**ADDENDUM NO. 2**

**PROJECT NAME:** East Stadium Bid Package 5  
**UNL PROJECT NUMBER:** C049P136

DATE OF ISSUANCE: January 9, 2012  
DATE OF BID OPENING: January 11, 2012

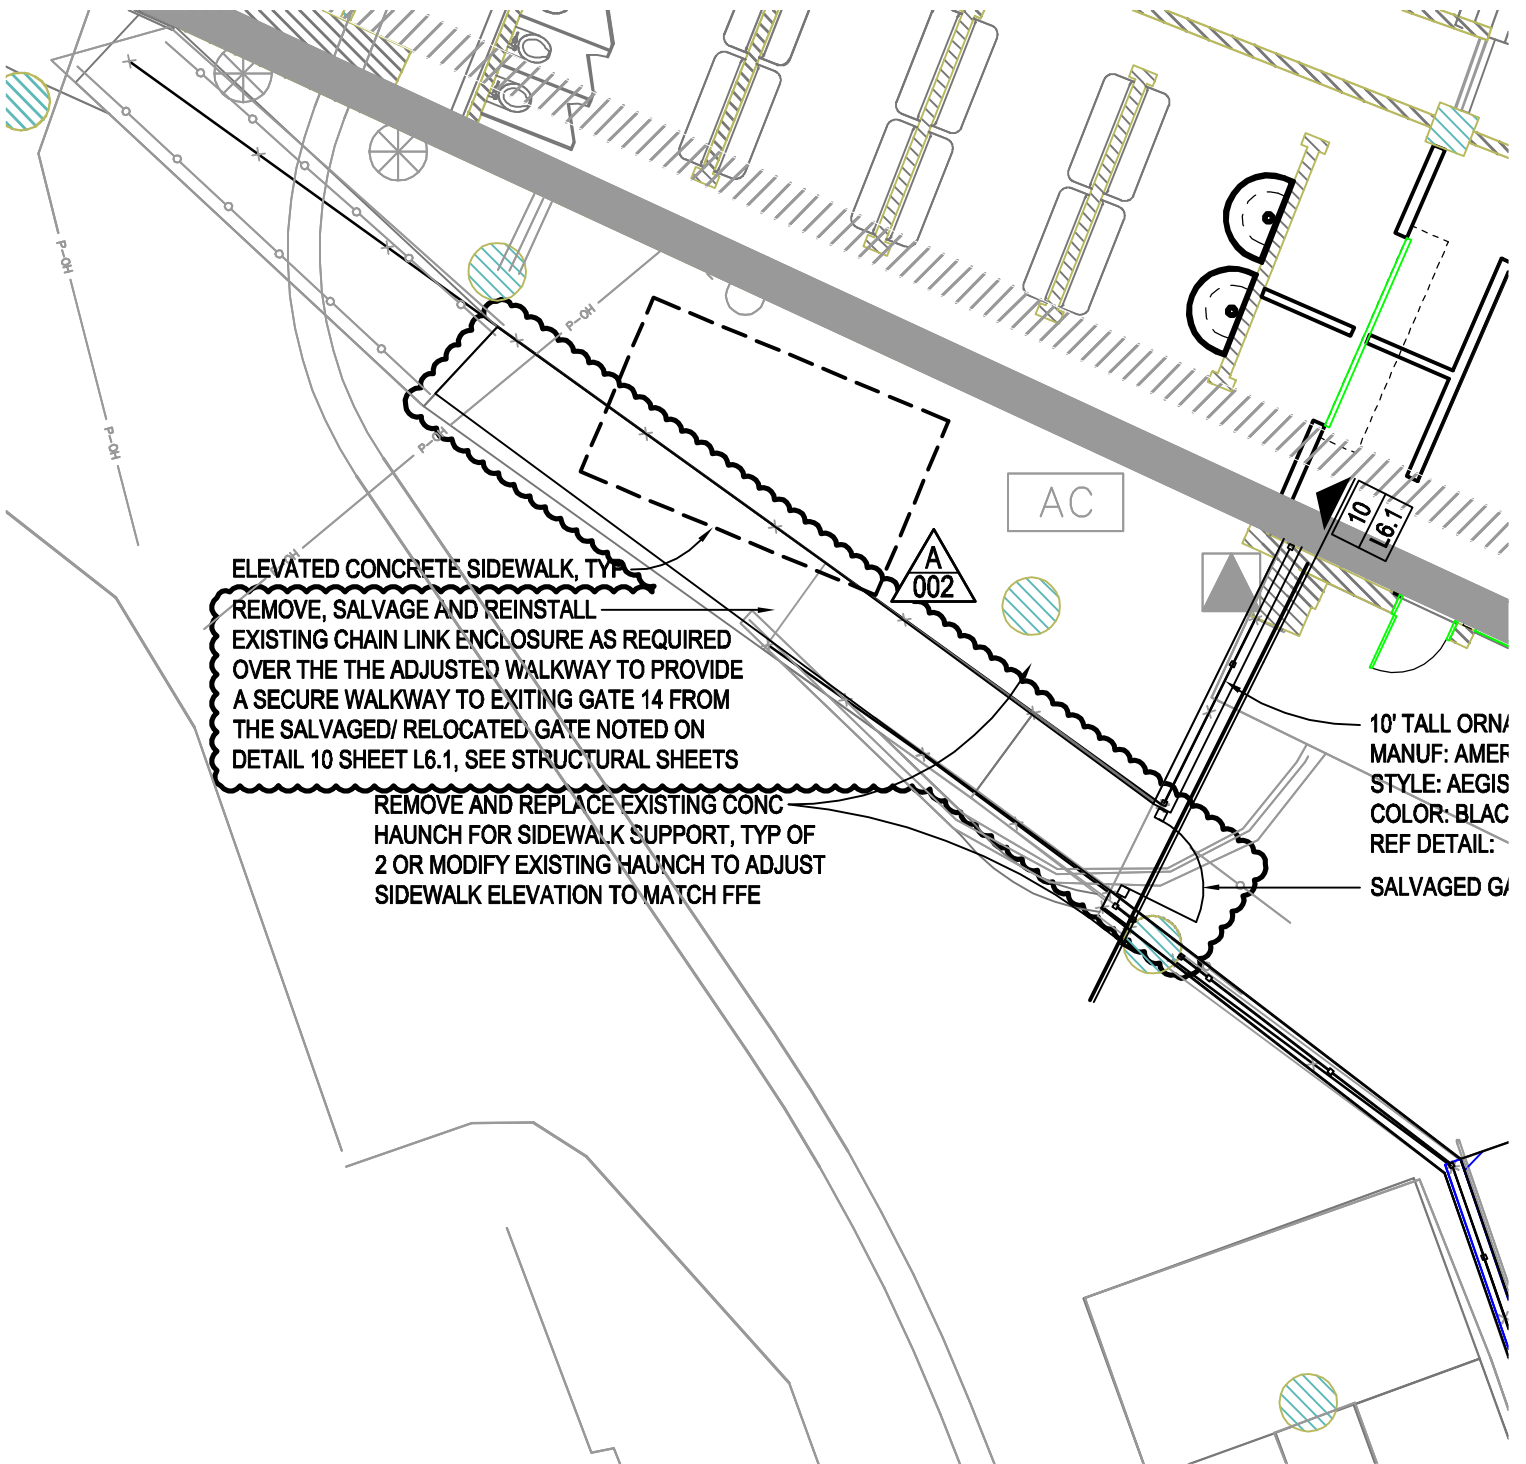
**Item #2-15 Refer to Drawings, Sheet L2.4 Site Layout Plan – Area ‘C’**

- a. Refer to the south existing elevated concrete sidewalk. Note that the existing chain link enclosure tunnel shall be removed, salvaged and reinstalled as required over the adjusted walkway to provide a secure walkway to existing gate 14 from the salvaged / relocated gate noted on detail 10 / L6.1 as indicated in SDL1.

Addendum #2  
 Supplemental Drawing: #SDL1  
 Revision of Sheet: L2.4  
 Date: January 9, 2012

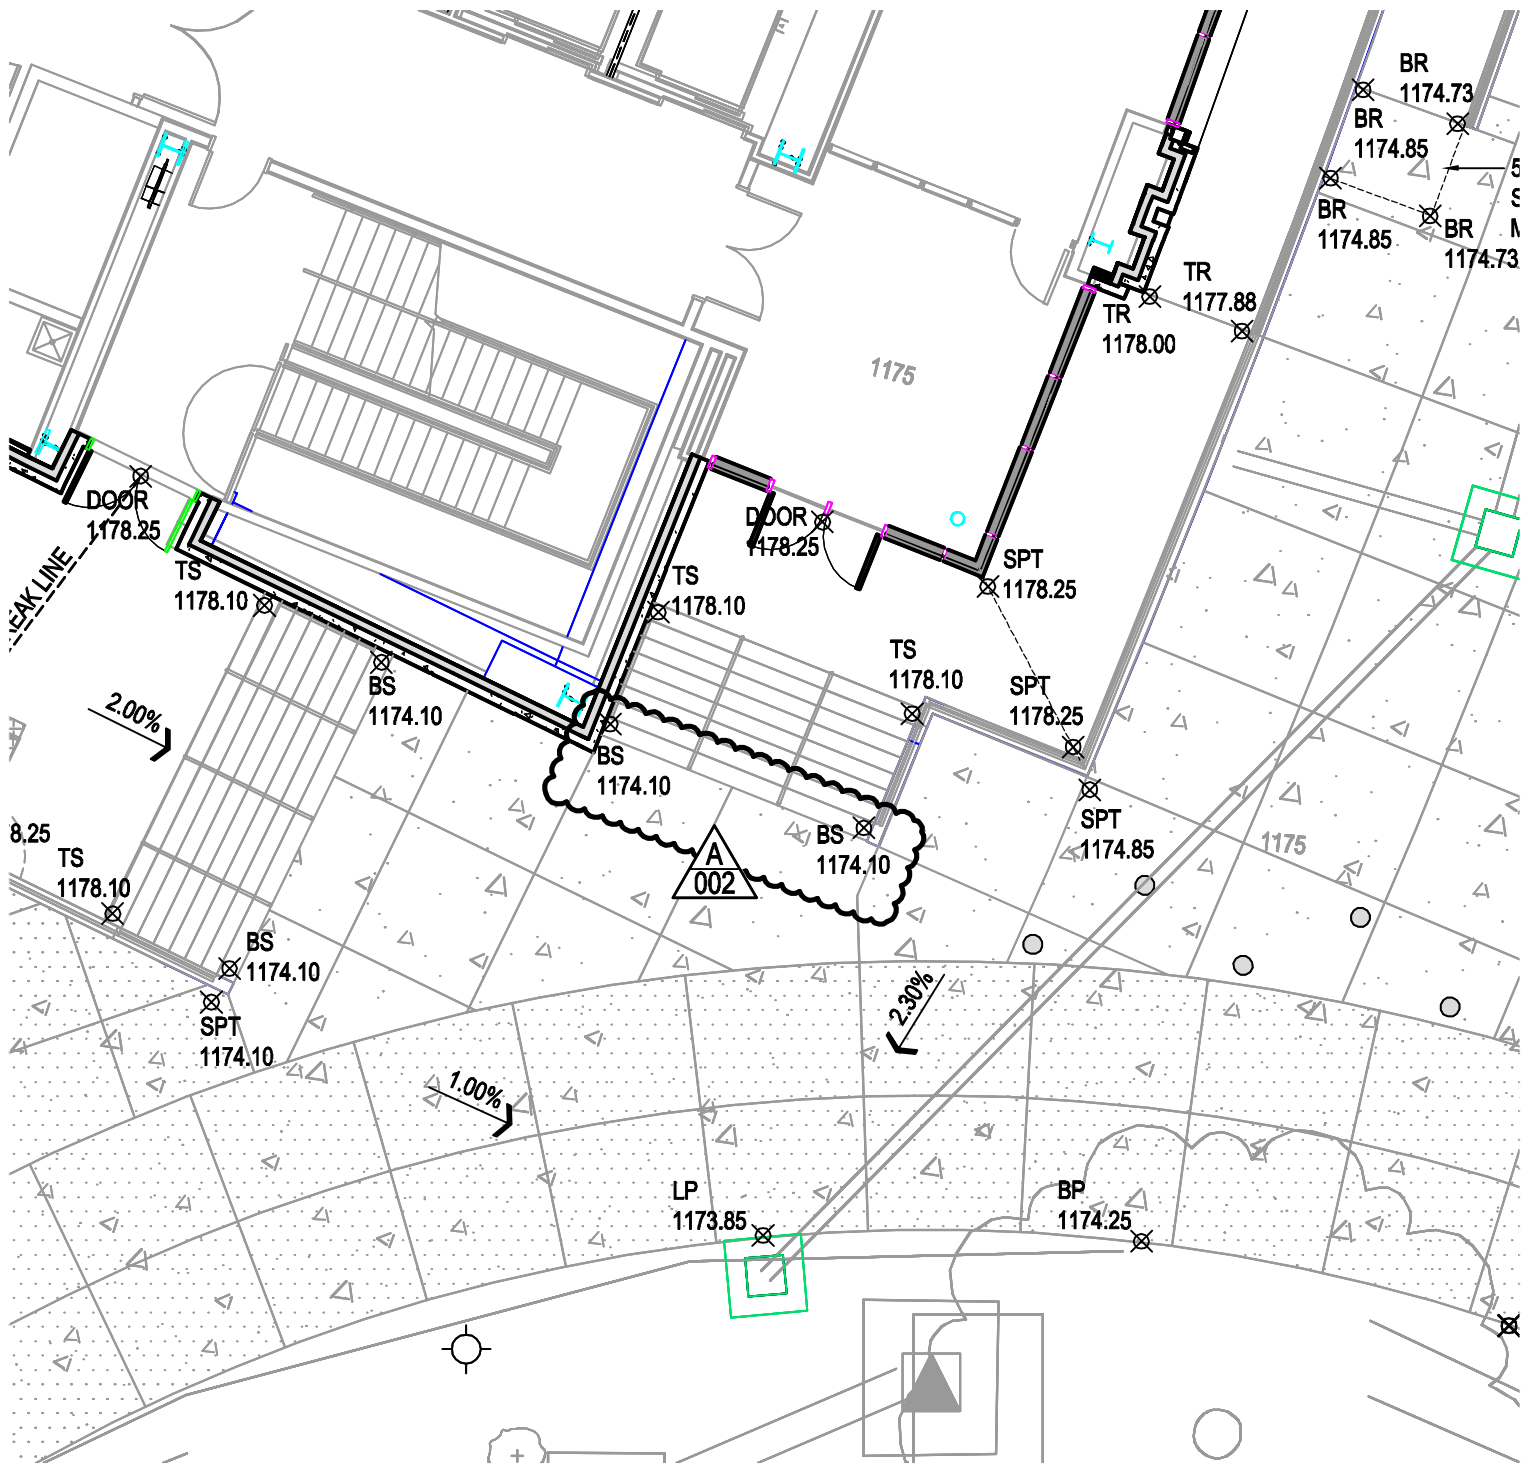
**Item #2-16 Refer to Drawings, Sheet L3.5 Site Grading Plan – Area ‘C’**

- a. Refer to exterior stairs at south east corner of building. Revise bottom of stair elevations as indicated in SDL2.

Addendum #2  
 Supplemental Drawing: #SDL2  
 Revision of Sheet: L3.5  
 Date: January 9, 2012

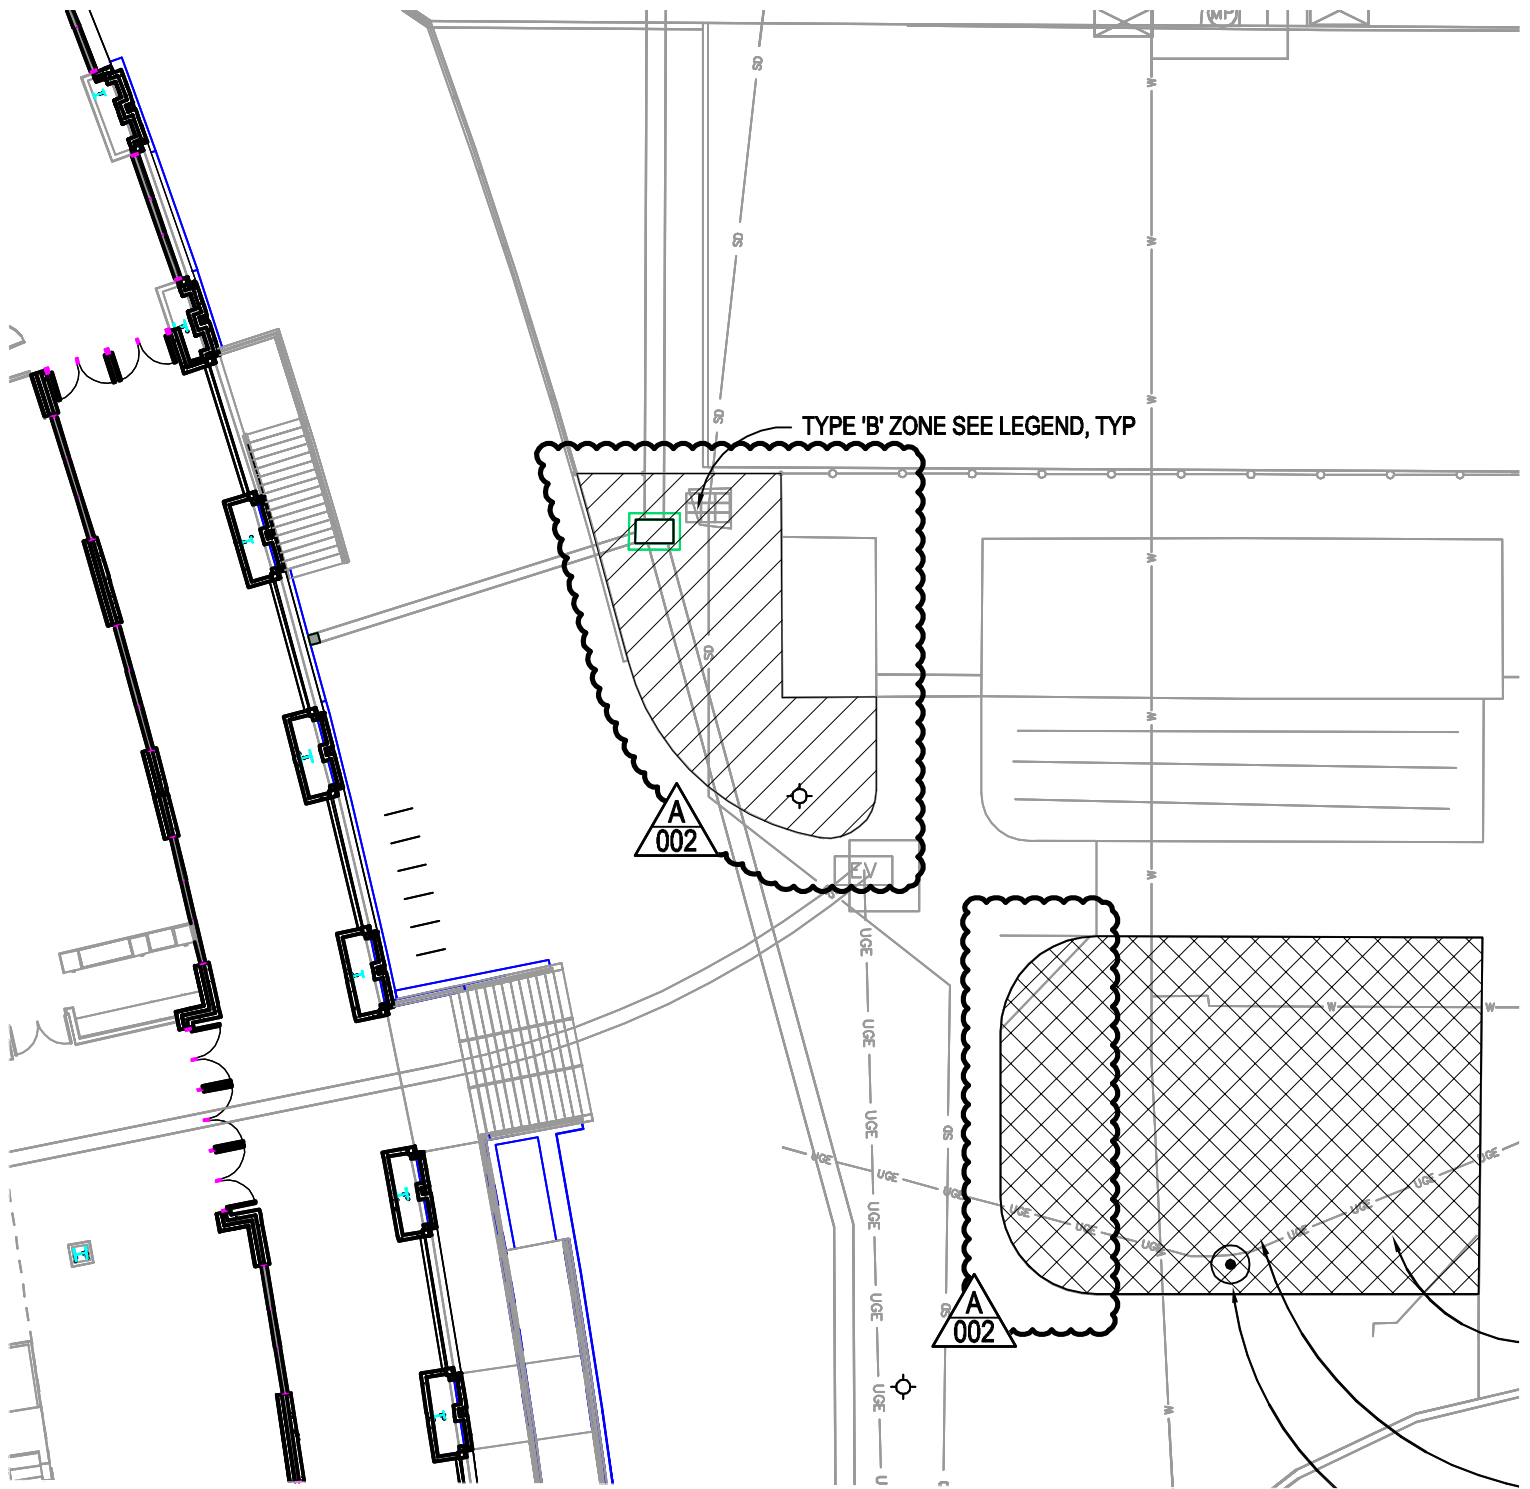
**Item #2-17 Refer to Drawings, Sheet L5.1 Site Irrigation Plan**

- a. Refer to irrigation area at north east corner of building. Revise irrigation hatch type as indicated in SDL3.
- b. Refer to irrigation areas at north east corner of building. Revise irrigation hatch area as indicated in SDL3.
- c. Add note to drawing: A 1.5" line will be available at each tie in location with approximately 20 gpm and 65 psi. Control wire will also be available at each point of connection.

# 9 SECTION DETAIL @ NORTH VESTIBULE PRECAST WALL

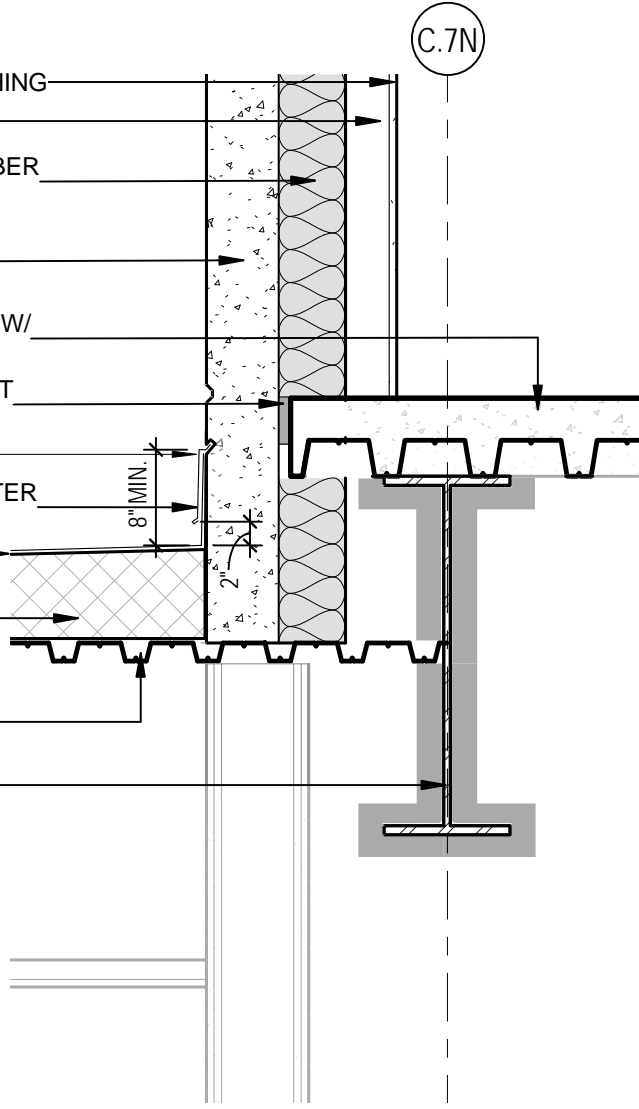
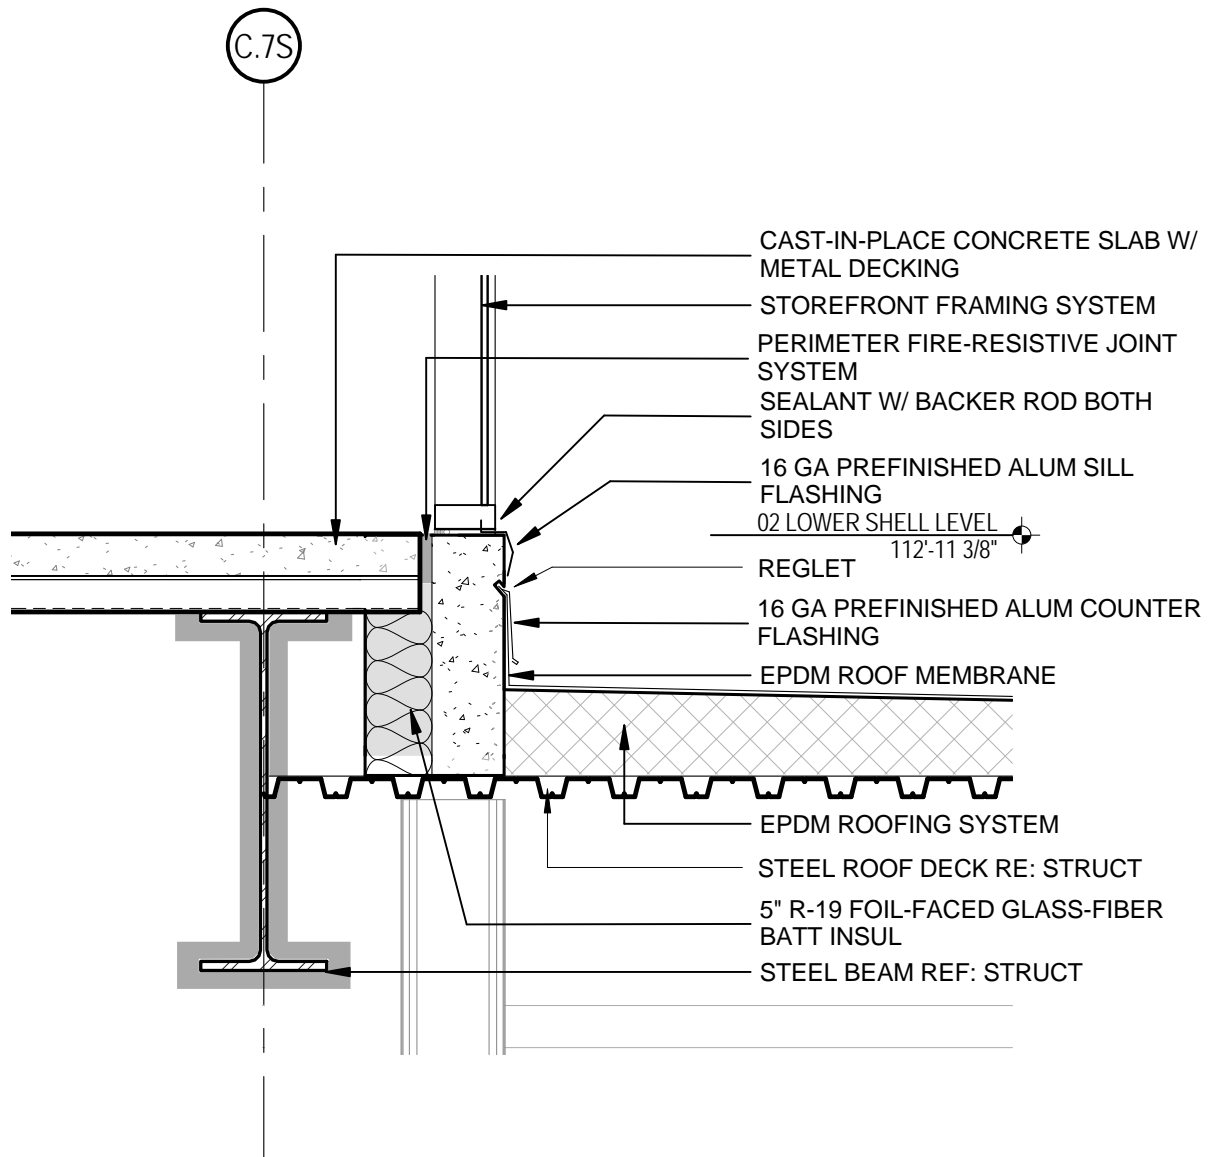
- a. Detail 9AE6.24 – CLARIFICATIONS – Refer to attached Architectural Supplemental Drawing, SDAE-5 for further detail and clarifications to this detail.
- b. Detail 10AE6.24 – CLARIFICATIONS – Refer to attached Architectural Supplemental Drawing, SDAE-6 for further detail and clarifications to this detail.
